## NON-MATERIAL AMENDMENT APPLICATION

June 2020  
Doc Ref. 682.SD.005A

Planning Permission 2018/5462/P NMA Document

Non-Material Amendment application document for planning permission 2018/5462/P (erection of 4x 3-storey, 3-bedroom dwelling houses with associated landscaping following demolition of existing 3x single storey garages.)

## 01 PROPOSED REAR ELEVATION

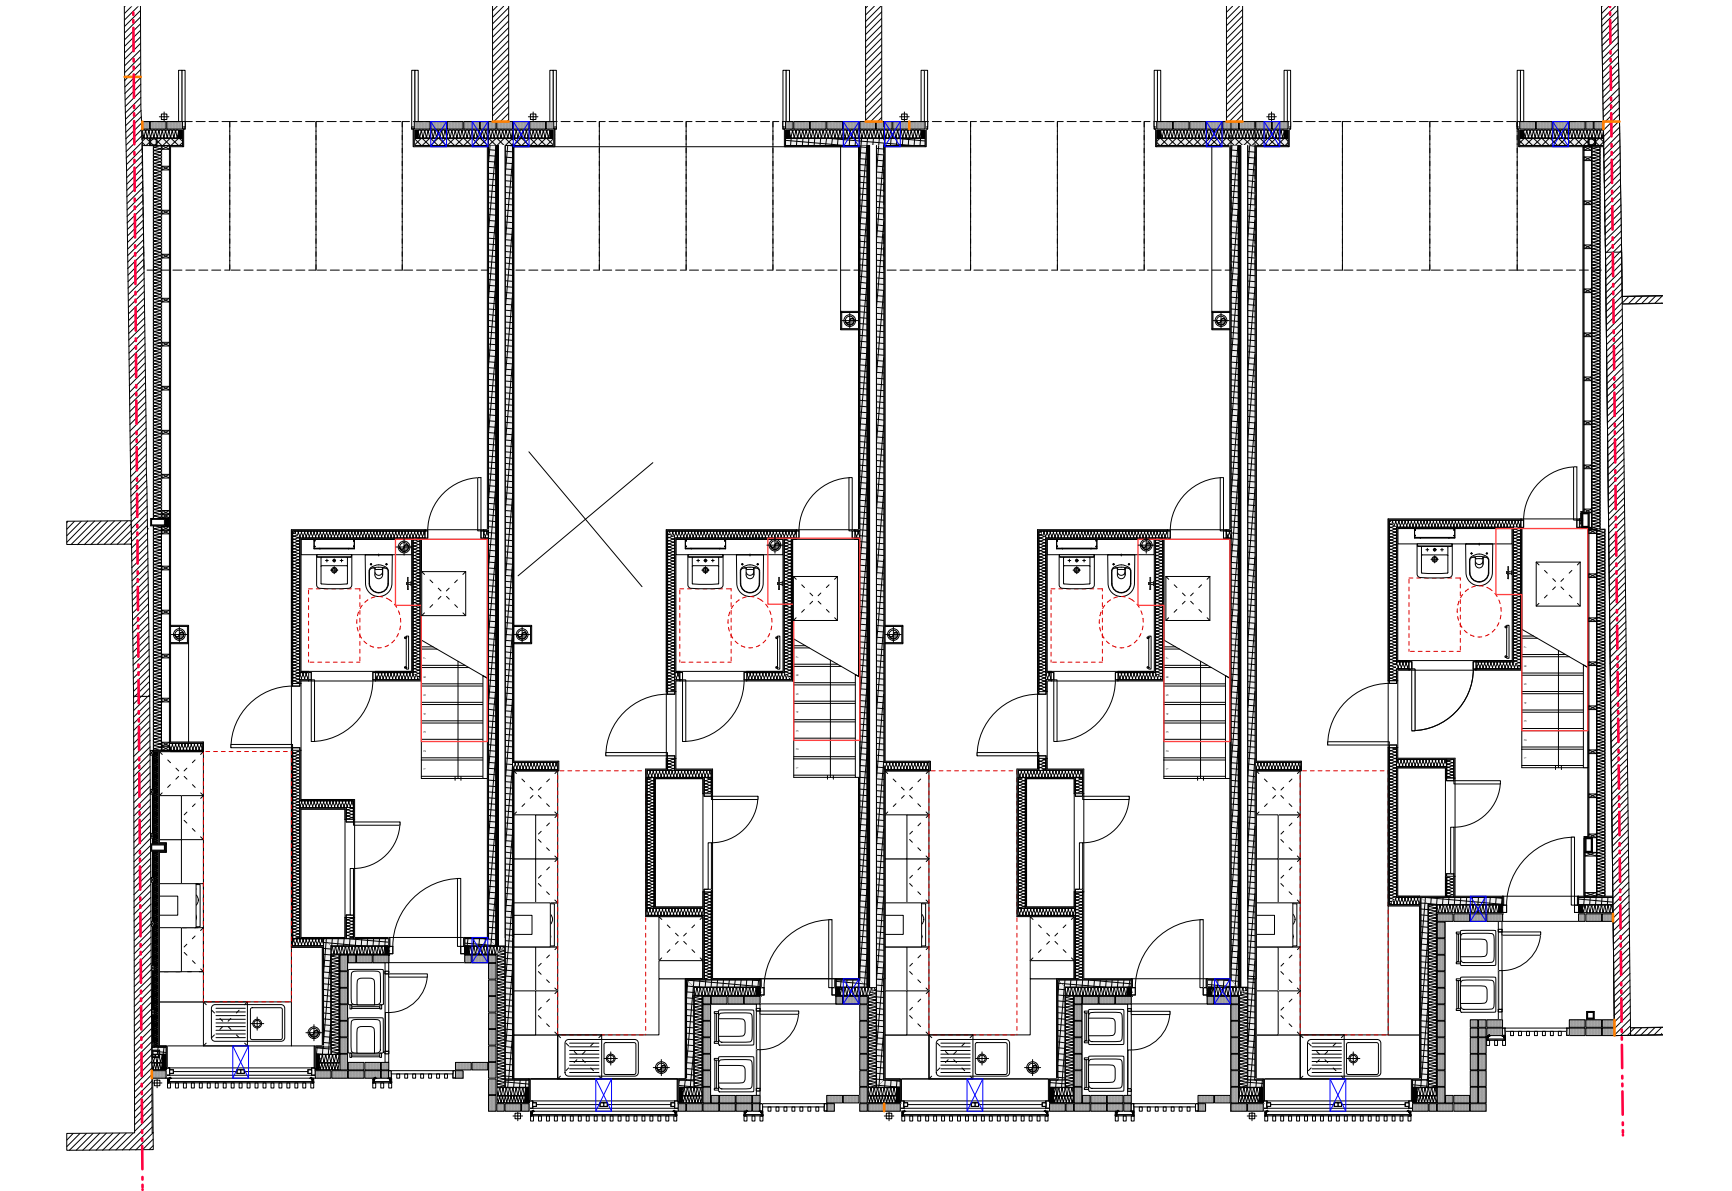
D212 decreased in width by approx. 300mm to fit in wall.

W103, W104, W106, W107, W109, W110, W112, W113 elongated to 2100mm from 1800mm as these are inward opening doors with glazed juliet balconies.

Rear bi-fold doors DG32, DG24, DG16 & DG08 decreased in height by one brick to allow for issues with levels in planning drawings.

Updated levels to reflect post-site-clearance survey and to allow for biodiverse roof build up.

Slightly increased gradient of lean-to roofs to rear to allow for rainwater run off.

NOTE: Amendments shown on plan. Other general changes include:

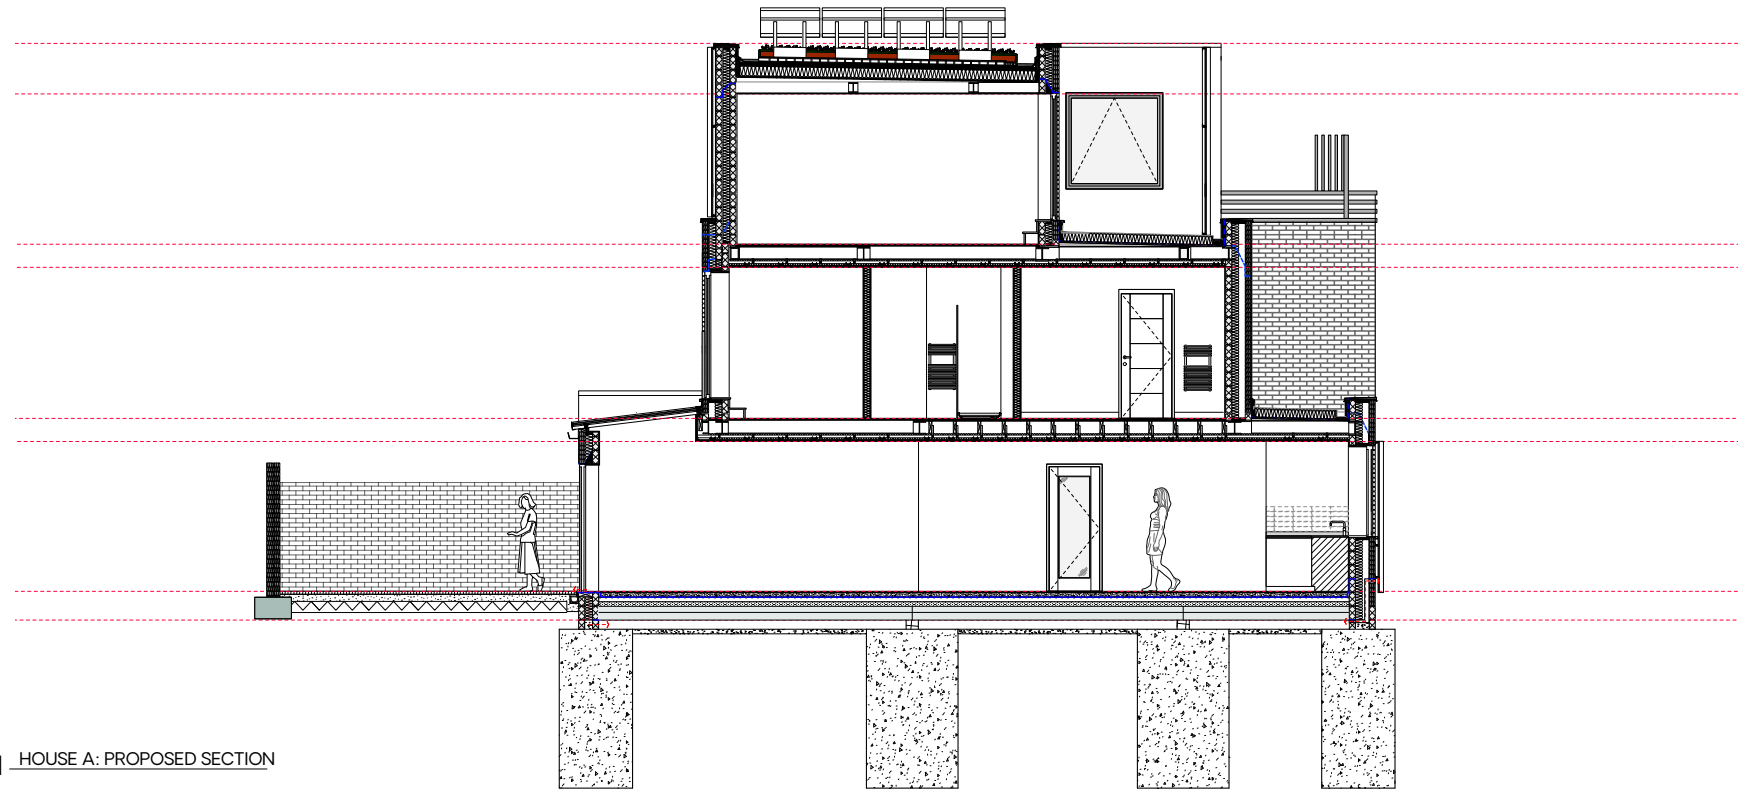
- Minor changes to windows as a consequence of brick setting out and post-site-clearance measured survey.
- Minor changes to layouts so to comply with building regulations.
- Minor alterations throughout to ensure scheme works as per planning scheme.
